Access Compliance Report Public Rights-of-Way (Curb Ramps)

Intersection ID: 48602 Main Street: S_TRYON_ST Cross Street: GRANDIFLORA_DR Location: NW

ADA ID: 72EF6A05D99A Ramp Type: PerpDiag Initial Pass/Fail: Fail Overall Compliance: No Severity Score: 33.75

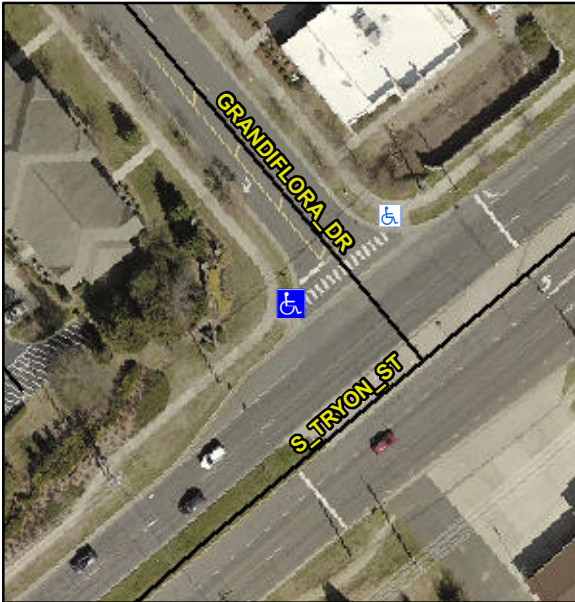
PROW/ADA:
Not Found, R304.5.1, R304.2.2, R304.5.3

| Compliance | Description | Data | Compliance | Description | Data |
|------------|-----------------------|-------|------------|-----------------------------|-------|
| N/A | Ramp Length (in) | 95.0 | No | Ramp Slope (%) | 8.9 |
| No | Ramp Width (in) | 47.5 | No | Ramp XSlope (%) | 6.1 |

Possible Solutions:
Remove & Replace Curb Ramp With Two New Directional Ramps or Equivalent.
